Access Compliance Report

Public Rights-of-Way

(Curb Ramps)

Intersection ID: 6851	Main Street: ANDREW_WARD_AV	Cross Street: MARGARET_TURNER_RD	Location: S
ADA ID: 2A3267B4D9E8	Ramp Type: Perp	Initial Pass/Fail: Fail	Overall Compliance: No
Severity Score: 21.25			
Codes/Mitigation Info/Possible Solution		Field Measurements/Component Compliance

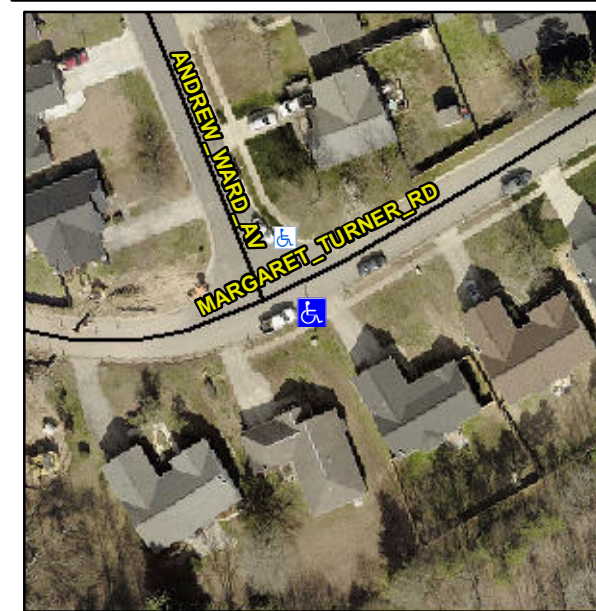
R304.5.1, R304.5.3

Compliance	Description	Data	Compliance	Description	Data
N/A	Ramp Length (in)	48.0	Yes	Ramp Slope (%)	7.1
No	Ramp Width (in)	42.0	No	Ramp XSlope (%)	6.3
N/A	Flare Type LT	N/A	N/A	Flare Type RT	N/A
N/A	Flare Slope LT (%)	N/A	N/A	Flare Slope RT (%)	N/A
N/A	Flare Traversable LT?	N/A	N/A	Flare Traversable RT?	N/A
N/A	Landing Length (in)	N/A	N/A	DWS Provided?	N/A
N/A	Landing Width (in)	N/A	N/A	DWS Contrast?	N/A
N/A	Landing Slope (%)	N/A	N/A	DWS Length (in)	N/A
N/A	Landing X Slope (%)	N/A	N/A	DWS Full Width?	N/A
N/A	Landing Curb? (Y/N)	N/A	N/A	DWS Offset (in)	N/A
N/A	Shared Landing?	N/A			
N/A	Gutter Ponding?	N/A	N/A	Gutter Slope (%)	N/A
N/A	Gutter Lip Ht (in)	N/A	N/A	Gutter X Slope (%)	N/A
N/A	Painted X Walk1?	No	N/A	Painted X Walk2?	N/A
	X Walk 1 Direction	To N		X Walk 2 Direction	N/A
N/A	X Walk 1 Width (in)	N/A	N/A	X Walk 2 Width (in)	N/A
	X Walk 1 Slope (%)	4.4		X Walk 2 Slope (%)	N/A
	X Walk 1 X Slope (%)	5.7		X Walk 2 X Slope (%)	N/A

Remove & Replace Entire Ramp.
